Kapalua Schematic

BDQ11/LA1601 Schematic with Capture CIS and Function field
uFCPGA Banias
02-12-2003
REV: 0.5

Version Change List (P. I. R. List)

Title		Odem(2 of 3)	
Size	Document Number	Rev	
C	BDQ11/LA-1601	0.5	
Date:	日期: 三月 06, 2003	Sheet	11 of 56

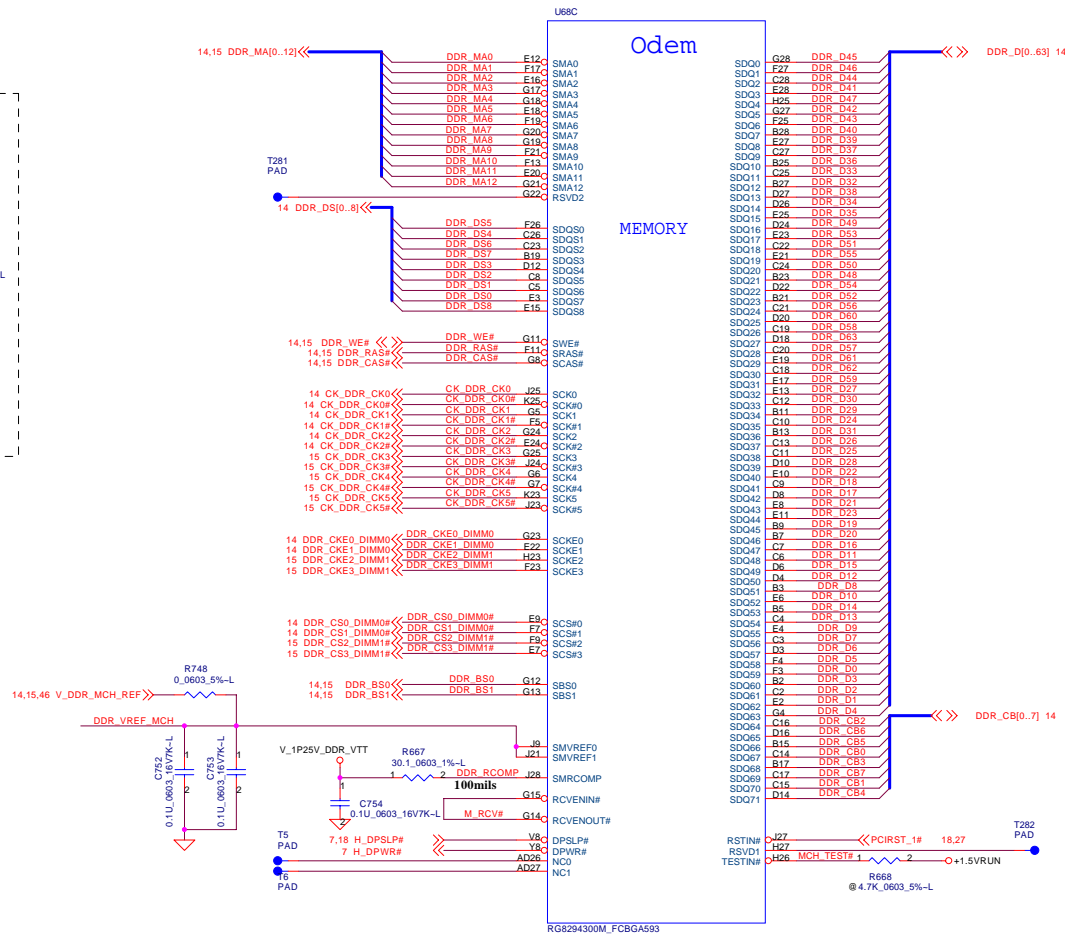
All of those schematic shall be changed to un-pop

Title		
DOCKING BUFFER		
Size	Document Number	Rev
	BDQ11/LA-1601	0.5
Date:	星期四, 二月 06, 2003	Sheet 32 of 56

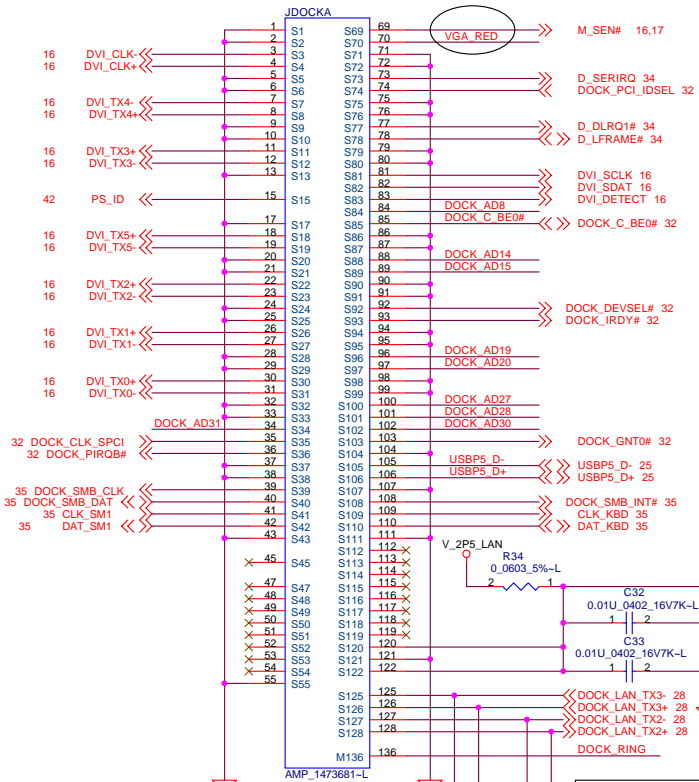
12/18 Item 73

12/18 Item 73

12/18 Item 73

Title		
PAD and Standoff		
Size	Document Number	Rev
	BDQ11/LA-1601	0.5
Date	星期三, 三月 06, 2003	Sheet 41 of 56

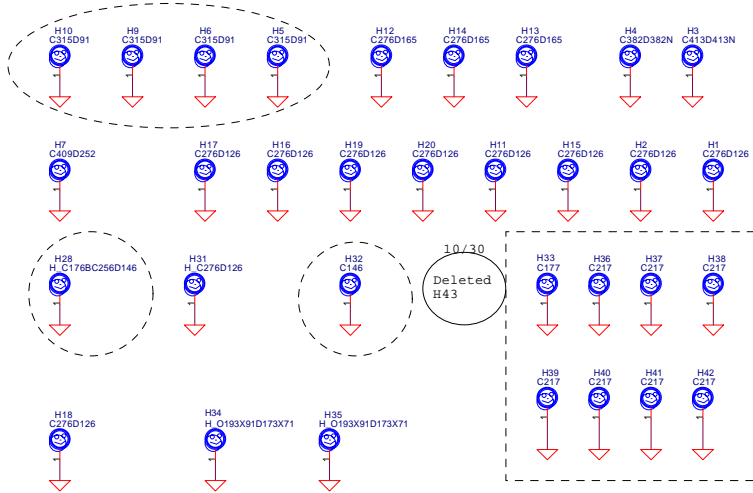
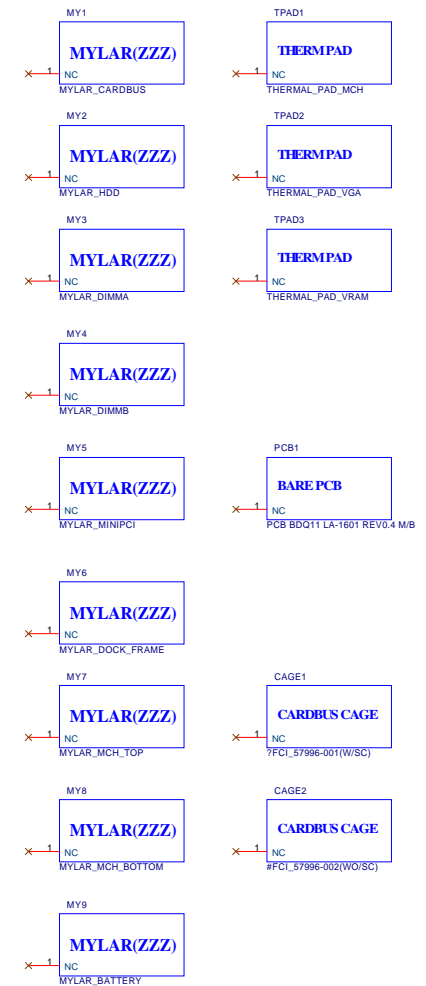
Deleted H43

11 / 27
For Cost-BOM

Item	Page#	Title	Date	Request Owner	Issue Description	Solution Description	Rev.
54	41	PAD & ME Parts	10/30/2002	Compal	Need to BLOW OUT 2.5mm Radius from Vias used to transition Tip and Ring from InnerLayer 4 to Bottom layer	Deleted H43 to meet 2.5mm Radius gap	X01
55	28	Magnetic & RJ45	10/30/2002	DELL	LAN Analog Switch (PI3L301BA) serial Resistors change type to Inductors	R776~R783 changed value from 0Ω to 15nH Inductor (TDK MLK1005S15NJ)	X01
56	27	POP option to 5705	11/08/2002	Compal	change the POP option from 5702 to 5705	Depop L66, C344, C324 Pop R217, R549	X01
57	38	Thermal shut down to 6509	11/08/2002	DELL	change the thermal shut down solution from discrete to MAX	Add U6, R30, R24 Depop U2, C29, R28, R20~R23, C27, R53, C65	X01
58	27	LOM	11/27/2002	Compal	Depop dummy parts	Depop R388 (10K_0402) and C390 (0.01U_0402)	X02
59	41	PAD, ME, SPARE PARTS	11/27/2002	Compal	Add Cost-BOM parts	Add Z1(Switch-FPC), Z2(Touch_pad-FPC), Z3(MDC-Cable), Z4(Spk-mODULE), Z5(BT_Cable).	X02

+2.5V/+1.25V

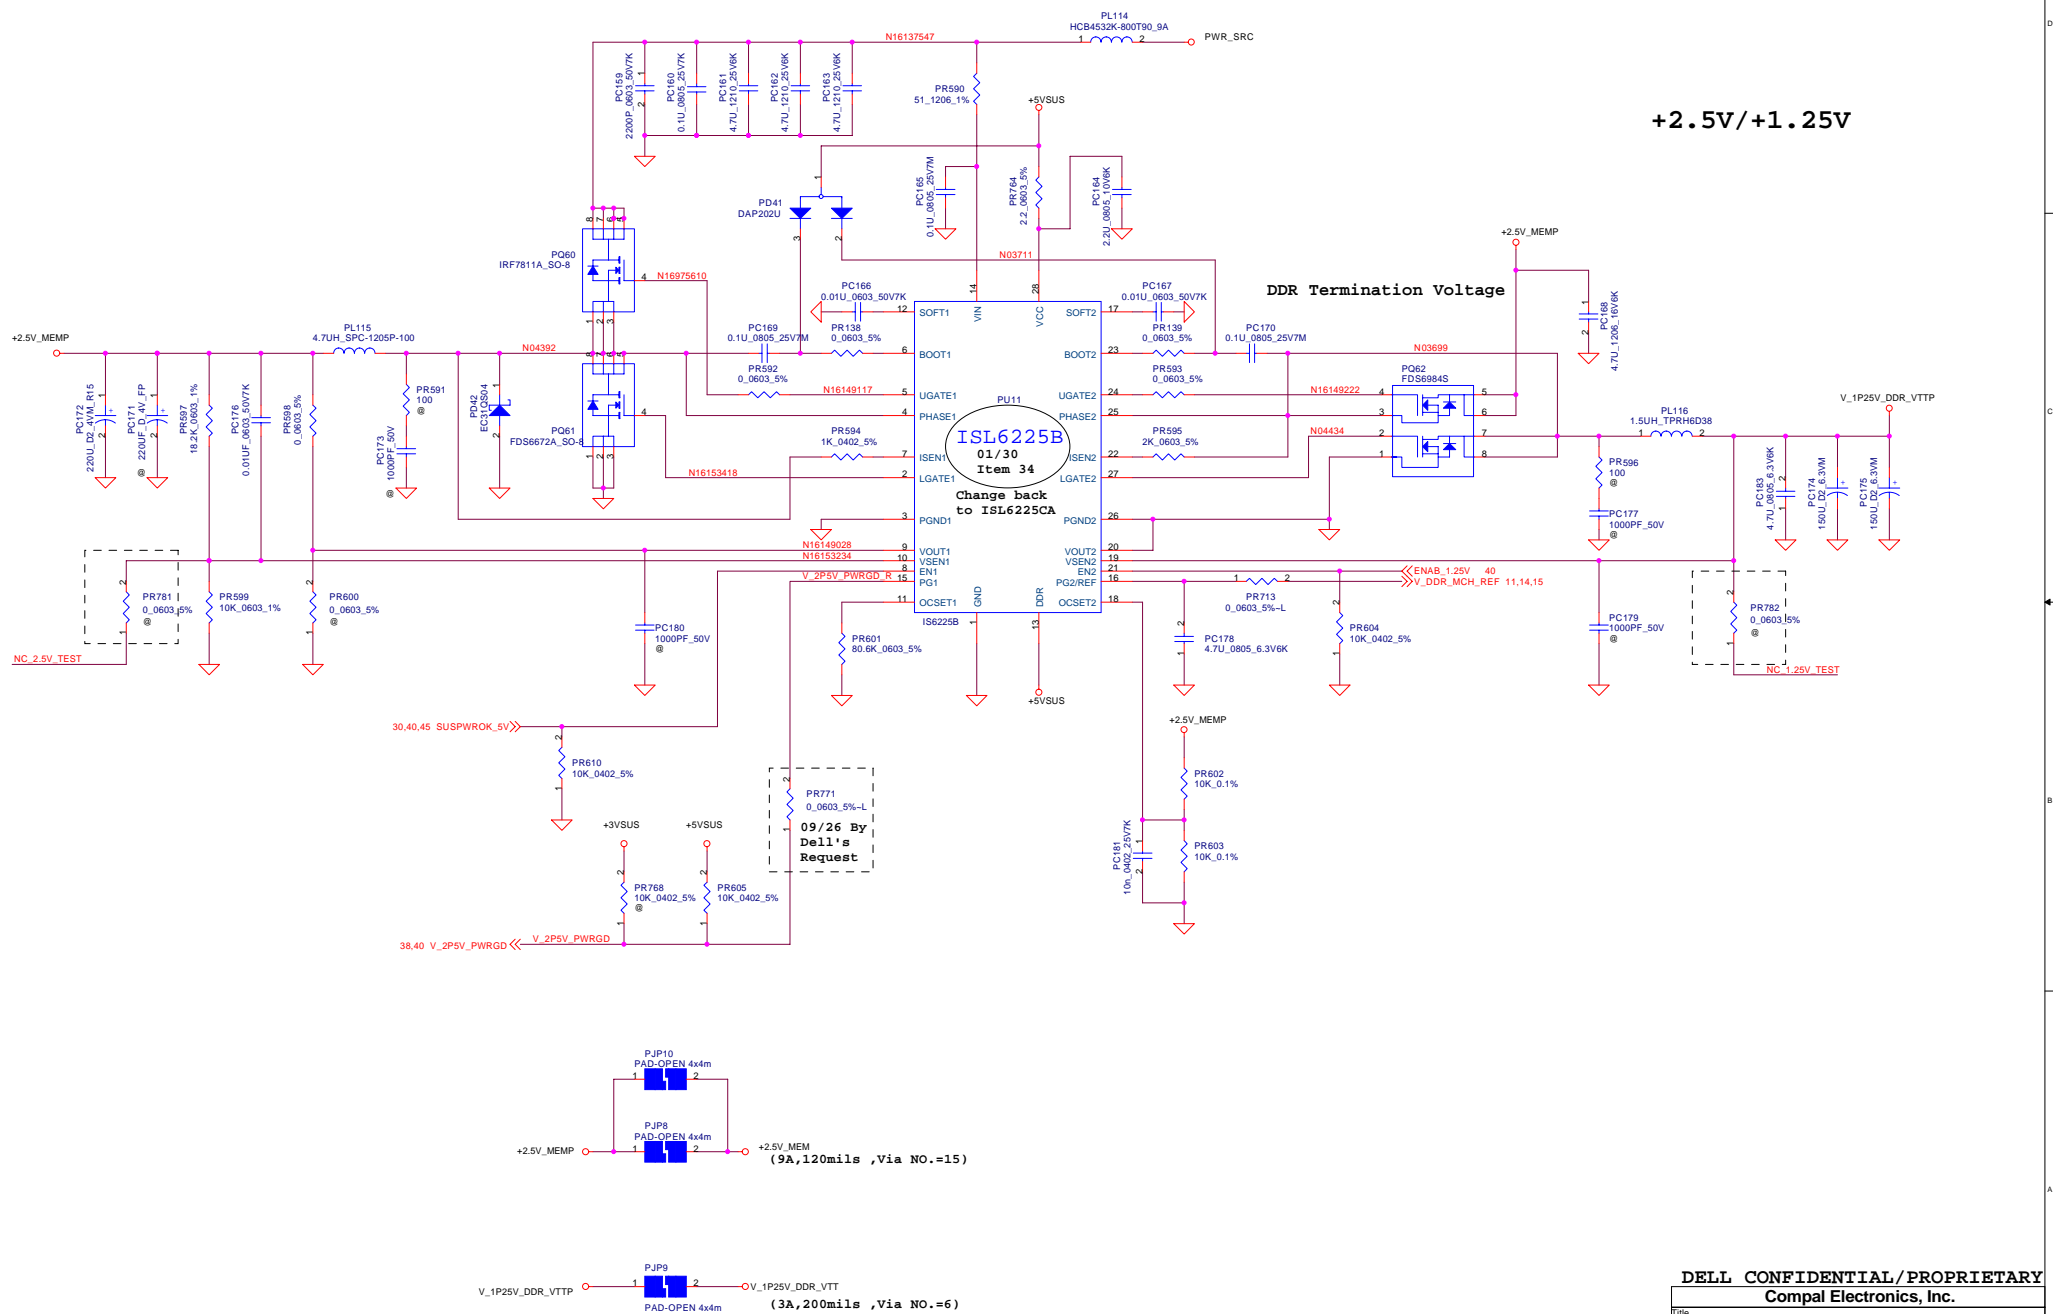
ISL6225B
 01/30
 Item 34
 Change back to ISL6225CA

Title		DC to DC	
Size	Document Number	BDQ11/LA-1601	
Date	Revision	06/06/2003	05
Sheet		48 of 56

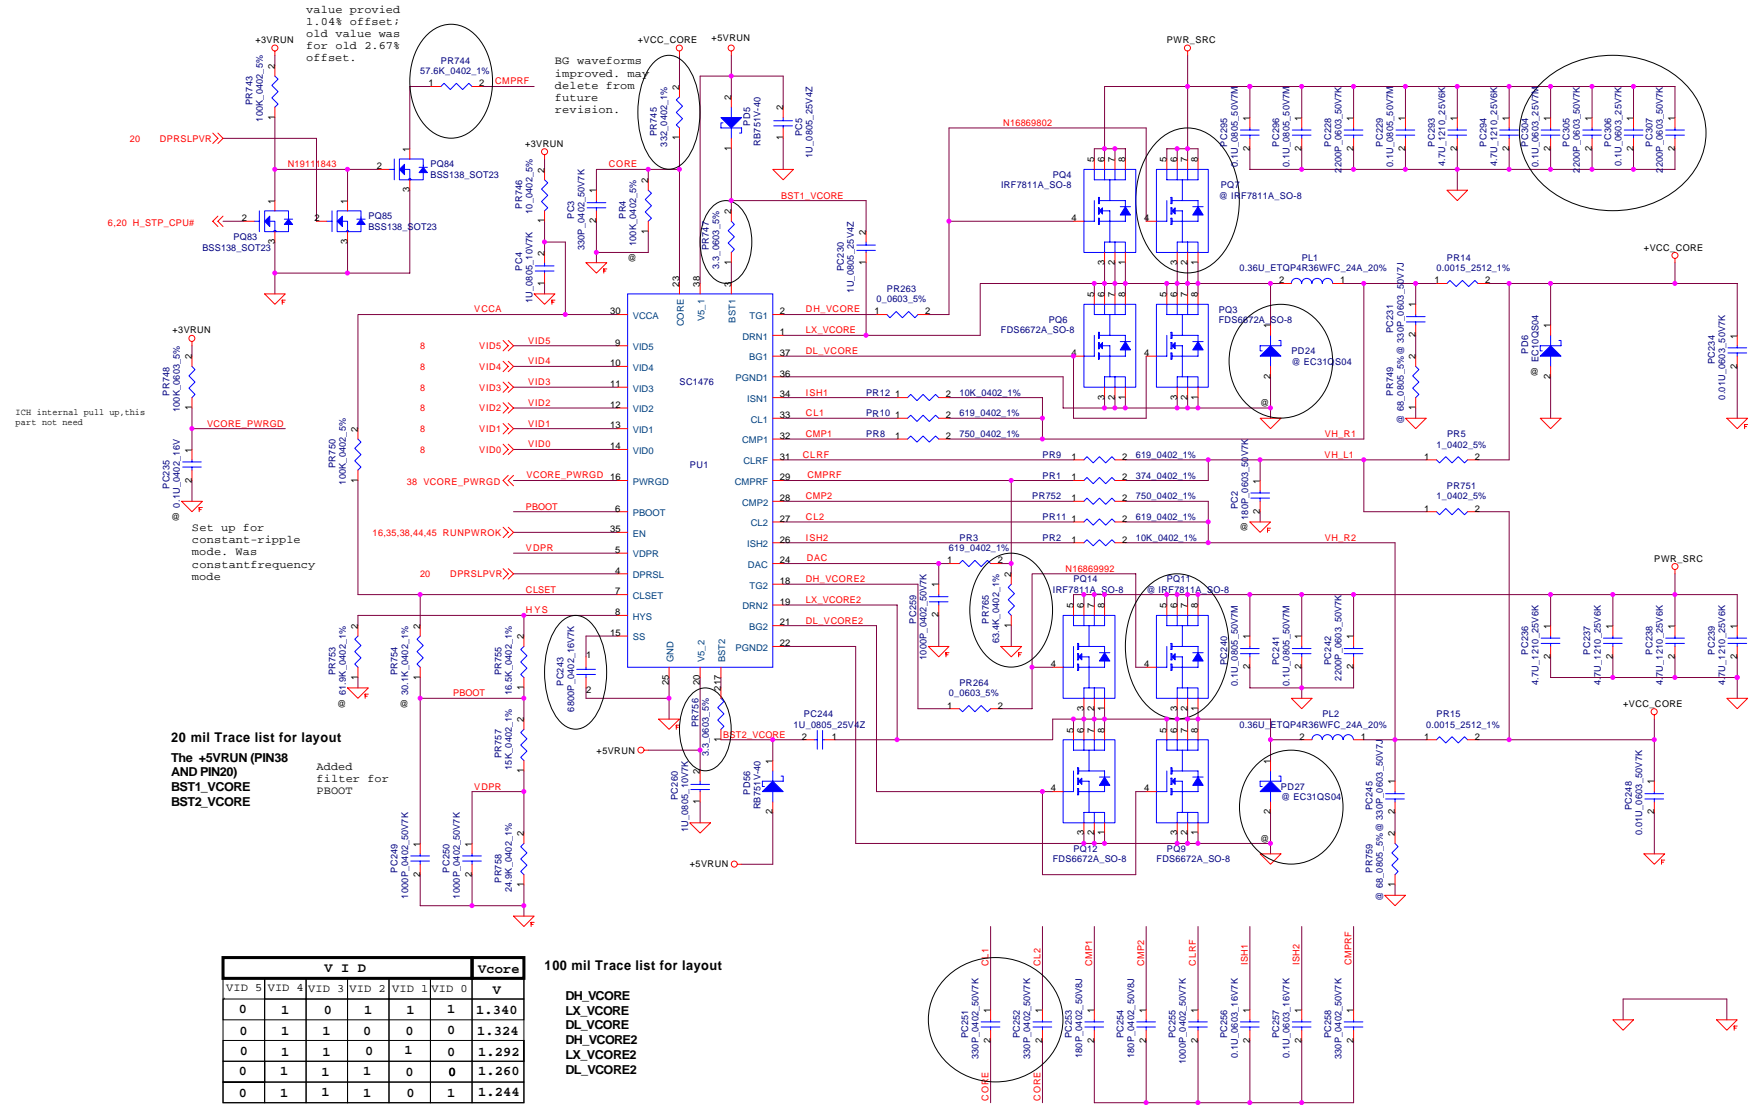
09/26 By Dell's Request

value provided
1.04% offset;
old value was
for old 2.67%
offset.

BG waveforms
improved, delete from
future
revision.

Set up for
constant-ripple
mode. Was
constant frequency
mode

DELL CONFIDENTIAL/PROPRIETARY		
Compal Electronics, Inc.		
Title		
CHARGER		
Size	Document Number	Rev
	BDQ11/LA-1601	0.5
Date:	星期四, 二月 06, 2003	Sheet 50 of 56

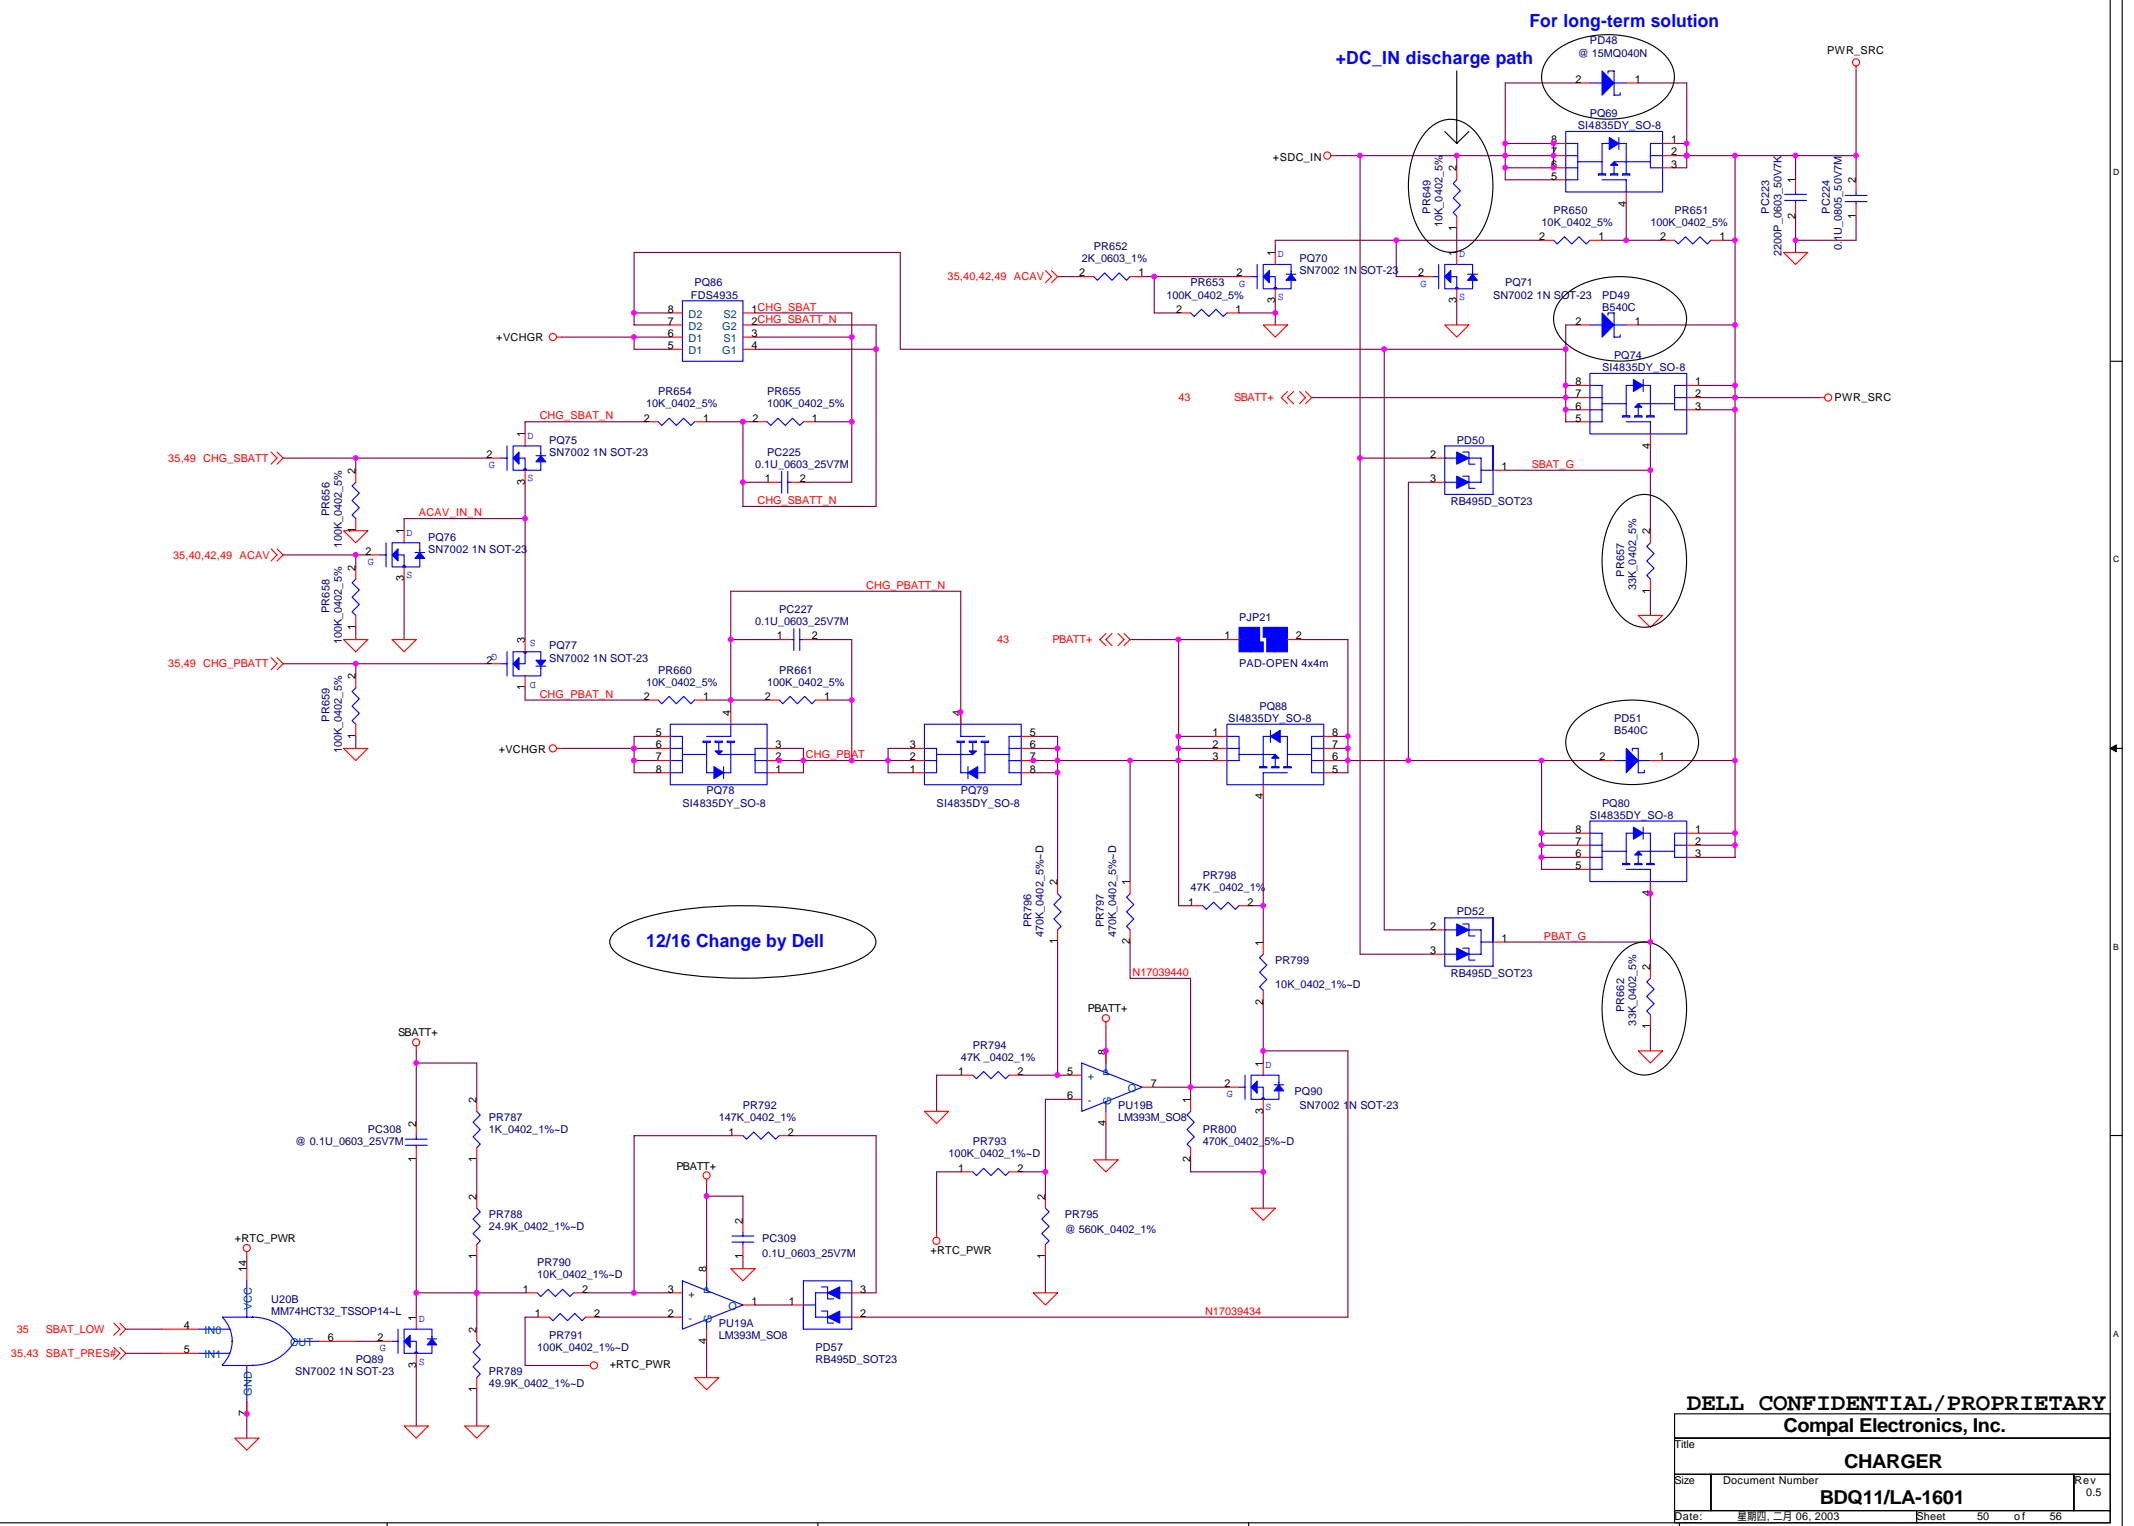
12/16 Change by Dell

For long-term solution
